RESOLUTION SETTING HEARING REGARDING REQUEST FROM WC MRP DES MOINES CENTER, LLC (OWNER), REPRESENTED BY NATIN PAUL, FOR REVIEW AND APPROVAL OF A 1ST AMENDMENT TO THE SOUTHDALE PUD CONCEPTUAL PLAN, ON PROPERTY LOCATED AT 4900 SOUTHEAST 14TH STREET, TO ALLOW EXPANSION OF RETAIL USE TO INCLUDE ADDITIONAL OUTDOOR DISPLAY AND MERCHANDISING IN THE PARKING LOT

(ZONG-2022-000099)

Communication from the City Plan and Zoning Commission advising that at their February 2, 2023 meeting, the following action was taken regarding a request from WC MRP Des Moines Center, LLC (owner), represented by Natin Paul (officer), for review and approval of a 1st amendment to the Southdale PUD Conceptual Plan on the property located at 4900 Southeast 14th Street, to allow expansion of a retail use to include outdoor display in the parking lot.

STAFF REPORT TO THE PLANNING COMMISSION

**CONCEPTUAL PLAN
 LANDSCAPE PLAN**

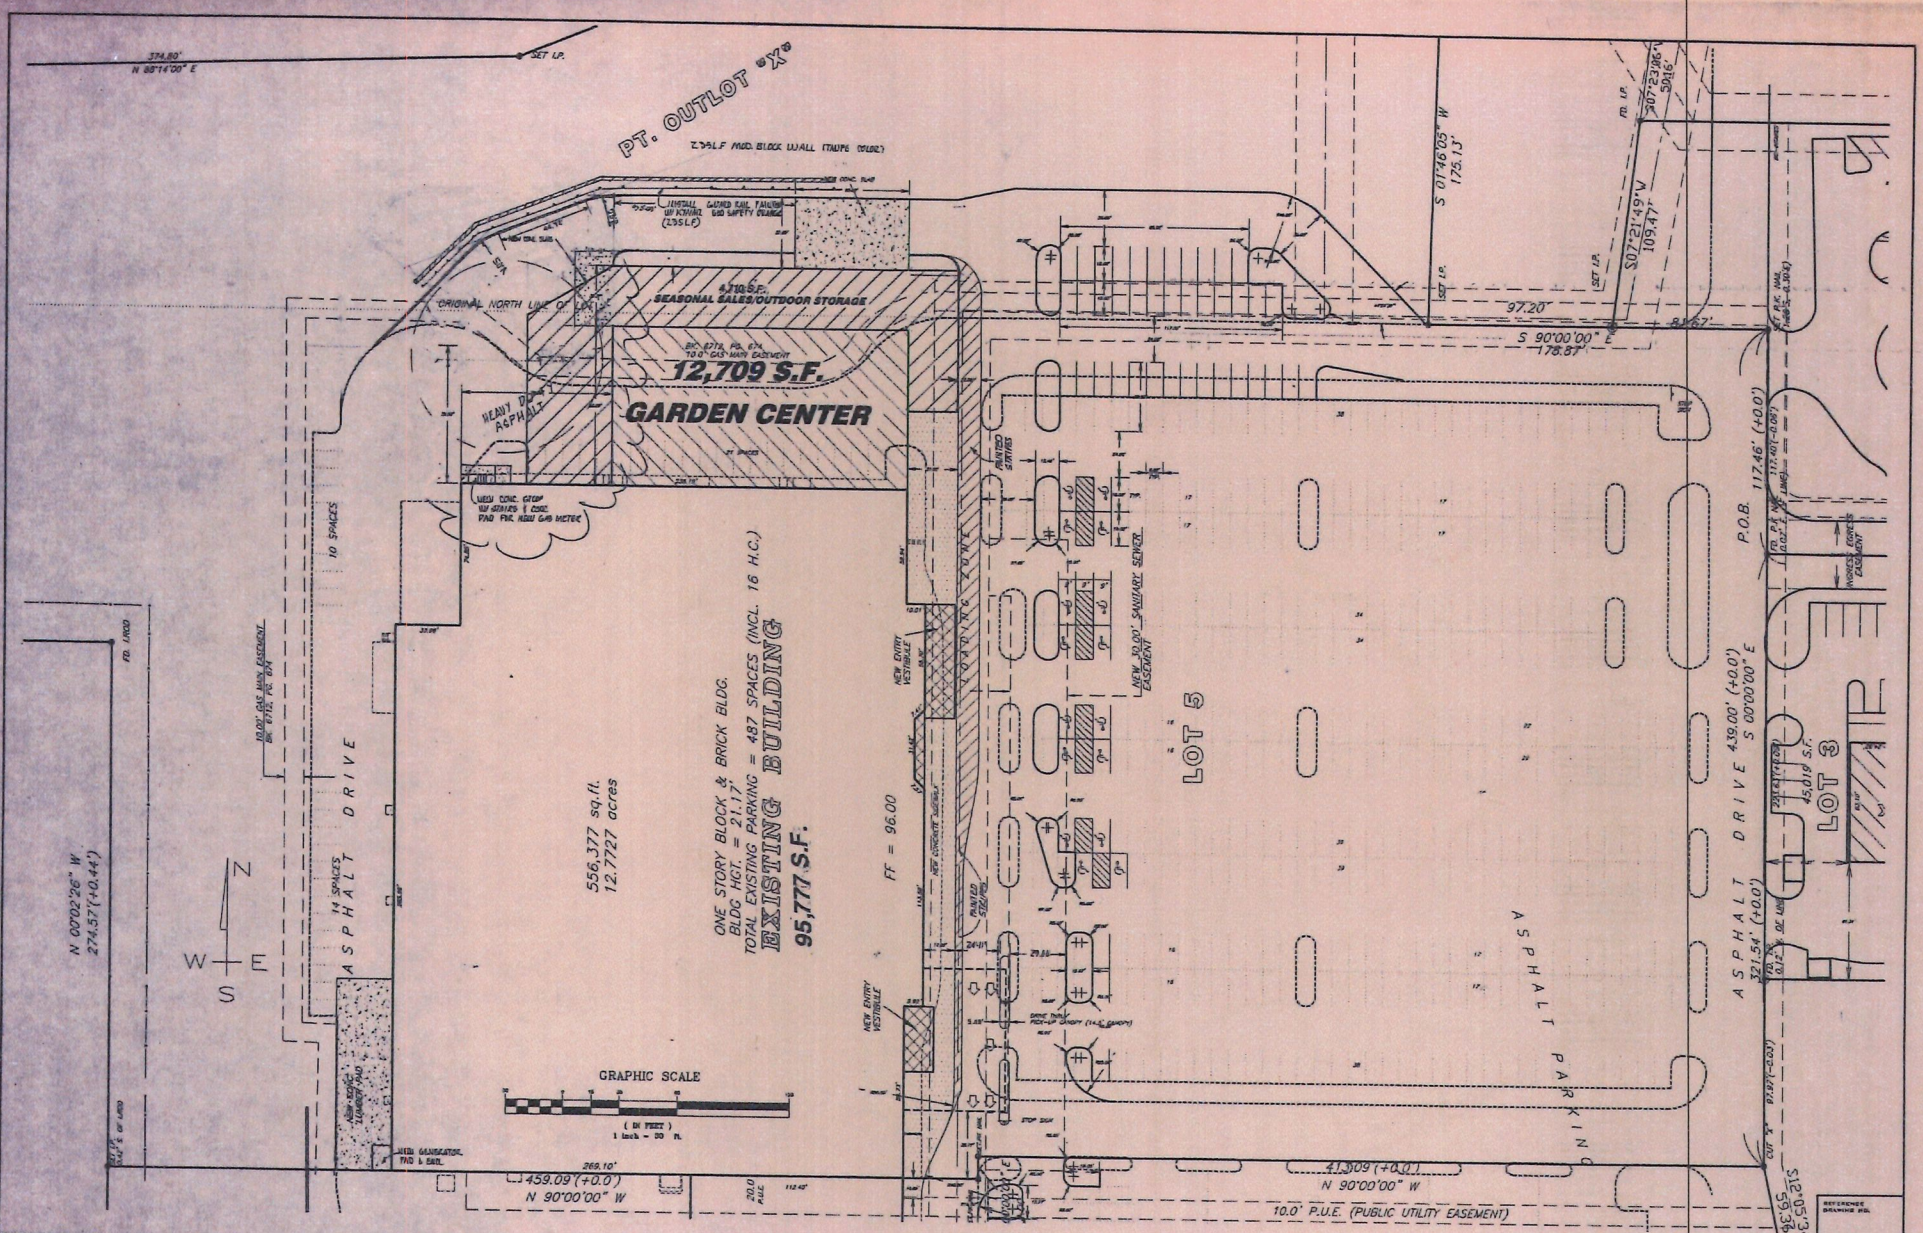
5. **Site Design:** The proposed location of the outdoor display would be adjacent to an existing interior drive aisle within the commercial development (southern side of the parking lot) and an existing 10-foot landscaping buffer in the front yard area. An existing “Seasonal Sales” area for outdoor display of merchandise was approved in 1999 as part of the plan. This “Seasonal Sales” area is located along the north facade of the building and the adjacent (northwest) corner of the parking lot. Staff recommends that any Outdoor Display associated with a Retail Sales Use, including the display of storage shed examples, should be limited to this existing area.

However, should the Commission and/or ultimately City Council be inclined to allow the display of storage sheds in the area requested, Staff recommends that the existing interior drive aisle have the appearance of a street right-of-way and compliance with the existing conceptual plan and/or installation of a frontage buffer (per City Code Section 135-7) to the satisfaction of the City’s Planning and Urban Design Administrator.

Bert Drost stated the site would be more organized and less visually cluttered if all of the outdoor merchandise is kept in the same area. If the commission was inclined to recommend approval of the request, staff suggests additional landscaping around the storage sheds be provided.

- 1) Any future construction or development of the site must comply with all applicable site plan and design regulations of the Planning and Design Ordinance (Chapter 135 of City Code), including the appearance of a street right-of-way on the existing interior drive aisle and compliance with the existing conceptual plan and/or installation of a frontage buffer (per City Code Section 135-7) to the satisfaction of the City's Planning and Urban Design Administrator.
